Form 3160-3 FORM APPROVED OMB No. 1004-0137 (June 2015) Expires: January 31, 2018 **UNITED STATES** DEPARTMENT OF THE INTERIOR 5 Lease Serial No. NMNM102034 BUREAU OF LAND MANAGEMENT APPLICATION FOR PERMIT TO DRILL OR REENTER 6. If Indian, Allotee or Tribe Name 7. If Unit or CA Agreement, Name and No. **✓** DRILL REENTER 1a. Type of work: 1b. Type of Well: ✓ Oil Well Gas Well Other 8. Lease Name and Well No. 1c. Type of Completion: Hydraulic Fracturing ✓ Single Zone Multiple Zone BANJO 32 FED COM 766H 9. API Well No. 30-015-54078 2. Name of Operator EOG RESOURCES INCORPORATED 3a. Address 3b. Phone No. (include area code) 10. Field and Pool, or Exploratory WC025 G09 S243336I/WOLFCAMP (GAS 1111 BAGBY SKY LOBBY 2, HOUSTON, TX 77002 (713) 651-7000 4. Location of Well (Report location clearly and in accordance with any State requirements.\*) 11. Sec., T. R. M. or Blk. and Survey or Area SEC 32/T25S/R30E/NMP At surface SWSW / 515 FSL / 1276 FWL / LAT 32.080464 / LONG -103.90794 At proposed prod. zone SWSW / 230 FSL / 1310 FWL / LAT 32.050466 / LONG -103.907788 12. County or Parish 14. Distance in miles and direction from nearest town or post office\* 13 State **EDDY** NM 15. Distance fro

Proposed Wellbore Design A

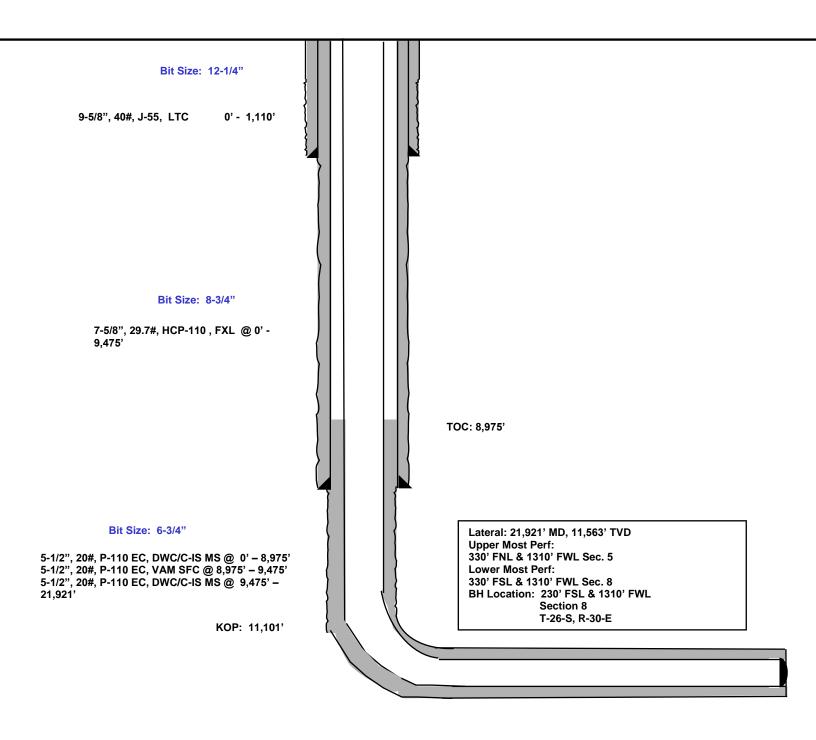
Operator has proposed to pump down 9-5/8" X 7-5/8" annulus after primary cementing stage. Operator must run Echo-meter to verify Cement Slurry/Fluid top in the annulus Or operator shall run a CBL from TD of the 7-5/8" casing to surface after the second stage BH to verify TOC.

- 3. The minimum required fill of cement behind the 5-1/2 inch production casing is:
  - Cement should tie-back at least 200 feet into previous casing string due to operator not meeting casing clearance requirement per 43 CFR 3170. Operator shall provide method of verification.
